Project **IEEE 802.16 Broadband Wireless Access Working Group** <<http://ieee802.org/16>>

Title **Clarification on the Key Hierarchy for the PKMv2**

Re: IEEE P802.16e/D8

IEEE C802.16e-05/281r1

Figure 131-AK with **the only PAK** (from RSA-based ~~only~~ authorization process)

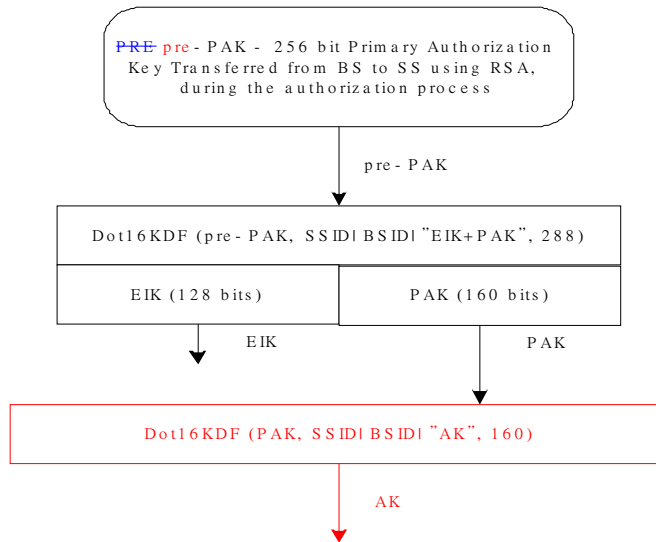
Figure 131 outlines the process to calculate the AK when the ~~RSA-based~~ authorization process has taken place, but where the EAP-based authentication process hasn't taken place, or the EAP method used has not yielded an ~~AAA-key~~ MSK:

Figure 132-AK with **PAK and PMK**

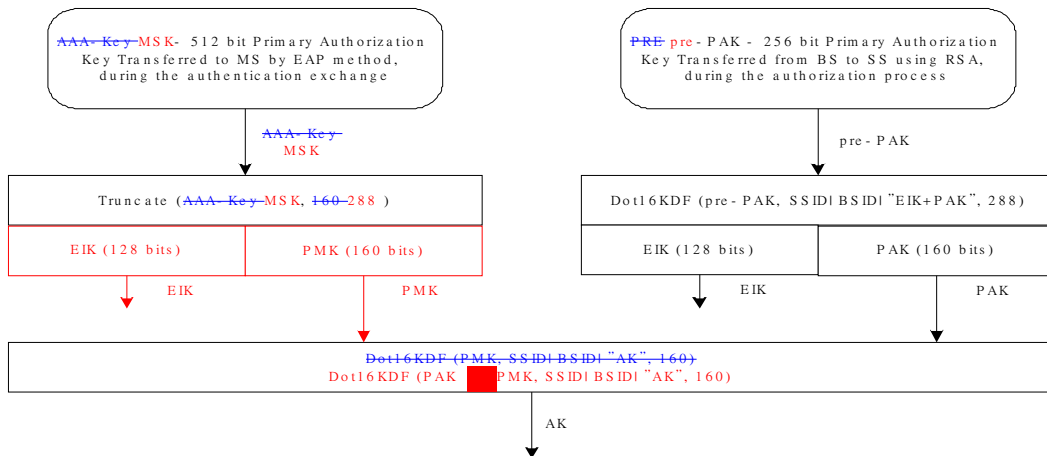
Figure 132 outlines the process to calculate the AK when both the **RSA-based** authorization exchange has taken place, yielding a PAK and the EAP based authentication exchange has taken place, yielding an **AAA-key MSK**:

Figure 133-AK with the only PMK (from EAP-based only authentication authorization process)

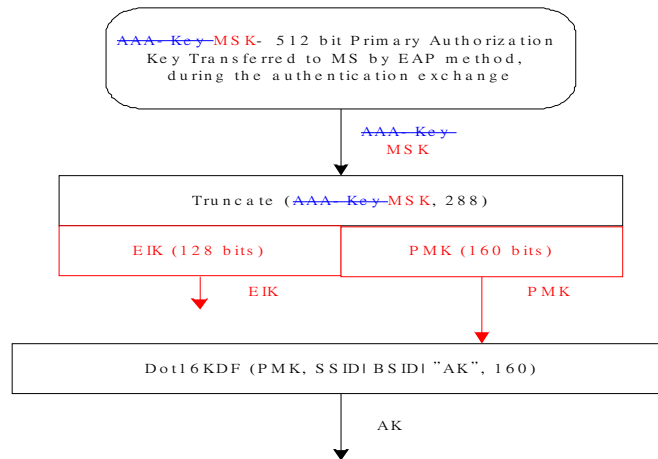
Figure 133 outlines the process to calculate the AK when only the EAP based authentication exchange has taken place, yielding an **AAA-key MSK**:
